State of Ohio Environmental Protection Agency

July 26, 2010

**Re: Construction Storm Water Inspection at Upper Hocking Wpcf/Pump Station/Force Main/Outfall Sewer Fairfield County
Permit Number: 4GC02932*AG**

Figure 1: Wetland area with construction outwash

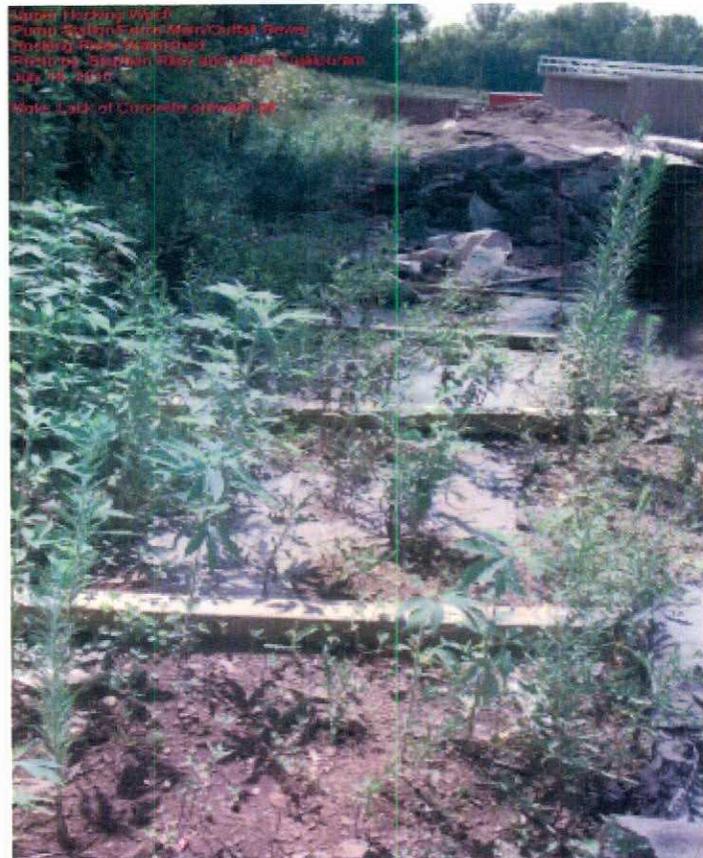
- During the inspection our staff noticed an uncontrolled storm water discharge from the construction site into an apparent wetland area (see figure 1). Corrective measures are expected to install sediment controls prior to the apparent wetland/impoundment.
- Our staff observed a concrete washout area on the east side of property which lacks a properly constructed washout pit. (See Figure 2)
- There is a lack of silt fencing separating the main road into the construction area and the low lying wetland to the south. (See Figure 3)
- There is a lack of sediment controls in the disturbed area which leads into a drainage swale on the east side of the property near the railroad tracks. (See figure 4)
- Our staff observed a sediment laden discharge into the Hocking River Tributary originating from the groundwater discharge pipe (See figure 5).
